Docket Number:	13-AFC-01
Project Title:	Alamitos Energy Center
TN #:	202163
Document Title:	Responses to CEC Staff Query 1â€™ Transmission and Project Description
Description:	N/A
Filer:	Sarah Madams
Organization:	CH2M HILL
Submitter Role:	Applicant Consultant
Submission Date:	4/21/2014 3:43:10 PM
Docketed Date:	4/21/2014

Subject: Alamitos Energy Center (13-AFC-01)
Staff Query 1– Transmission and Project Description

FIGURE 3.1-1aR2
System One Line Diagram - Power Island,
Units 1 and 2
Alamitos Energy Center
Long Beach, California

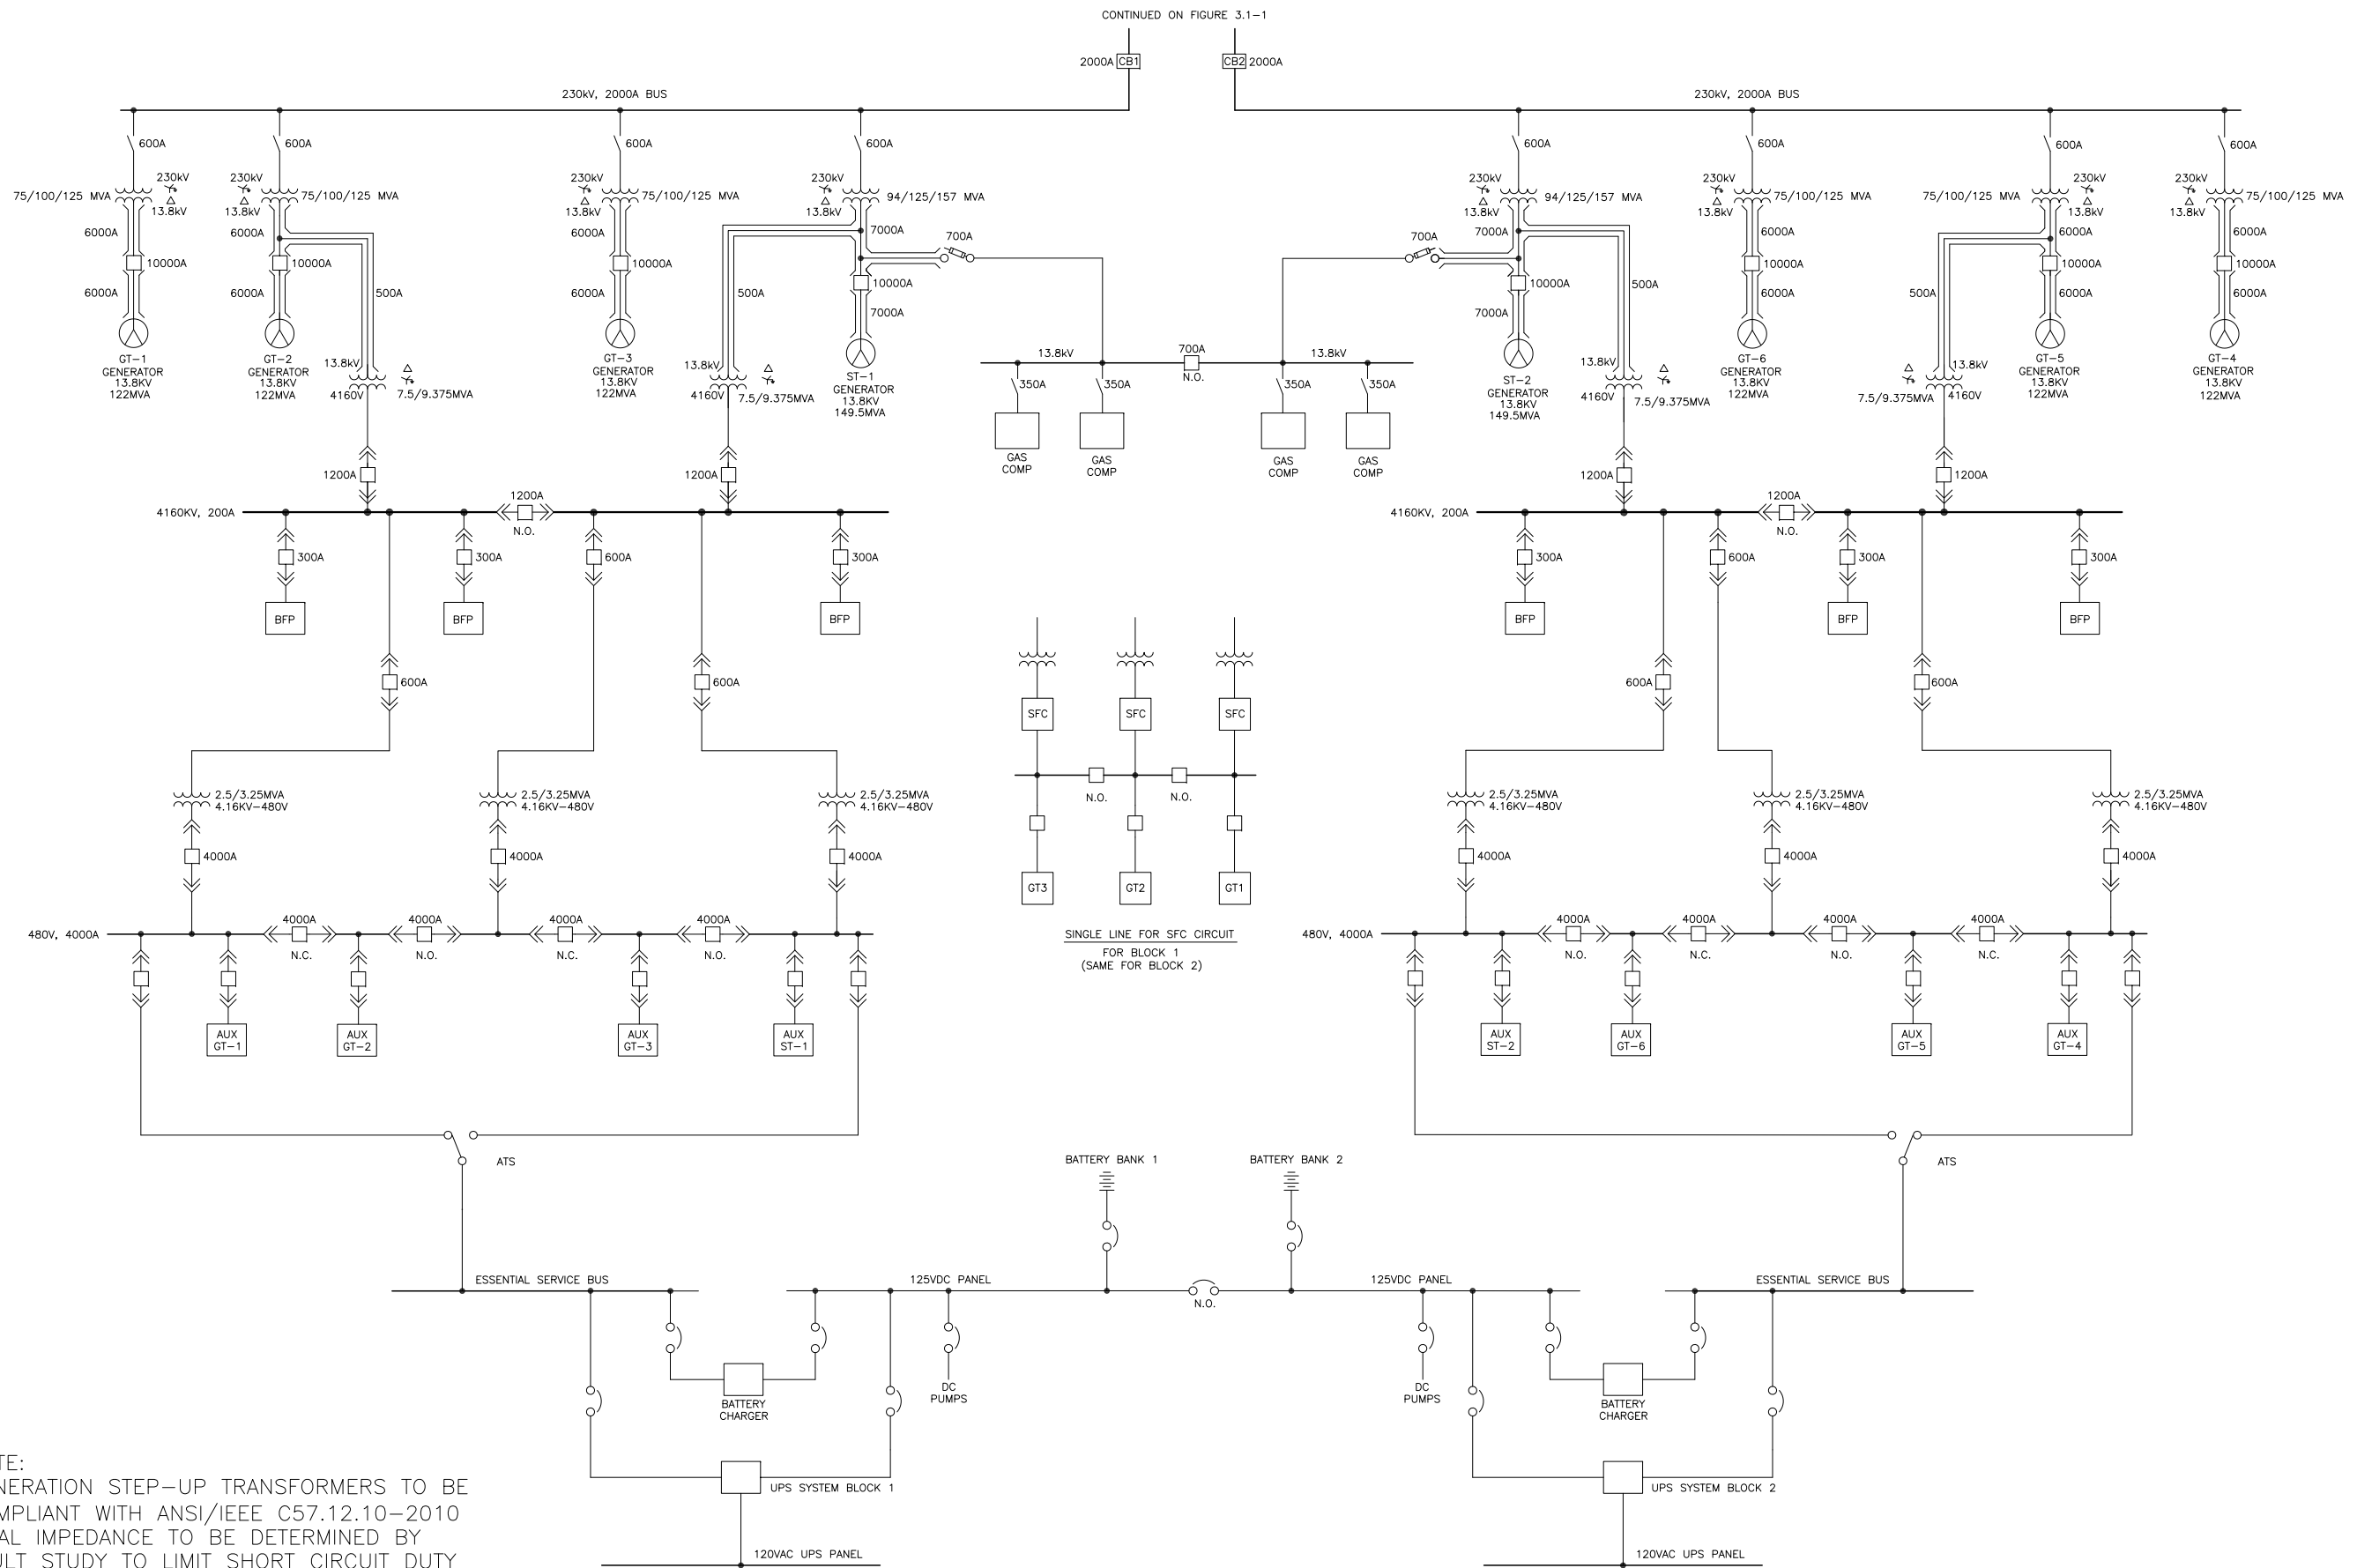
- The KVA rating of the transformer shall be based on its capacity at ONAN cooling stage. When fans and/or pumps are added to the transformer (forced cooling), its rating shall be increased by the percentage as indicated in Table 1. Please resubmit Figures 3.1-1aR thru Figure 3.1-1cR with adequate minor correction of the generator step-up transformer MVA ratings based on Section 4.2.2 of ANSI/IEEE Standard C57.12.10-2010. Along with the corrected ratings of the GSU (Generator Step-Up) transformers, please also provide in the figures the percentage impedance of the respective GSU transformer for its base MVA rating with a comment that the transformer oil temperature will not exceed 65 degree C as stated in the IEEE Standard.*

Response: Revised one line drawings including updated transformer ratings, impedances, and temperature are provided as Figures 3.1-1aR2 and 3.1-1bR2. Figure 3.1-1cR2 required no updates. Ratings conform to Section 4.2.2 of ANSI/IEEE Standard C57.12.10-2010.

NOTE:
GENERATION STEP-UP TRANSFORMERS TO BE
COMPLIANT WITH ANSI/IEEE C57.12.10-2010
FINAL IMPEDANCE TO BE DETERMINED BY
FAULT STUDY TO LIMIT SHORT CIRCUIT DUTY
ON SCE 230KV ALAMITOS BUS.
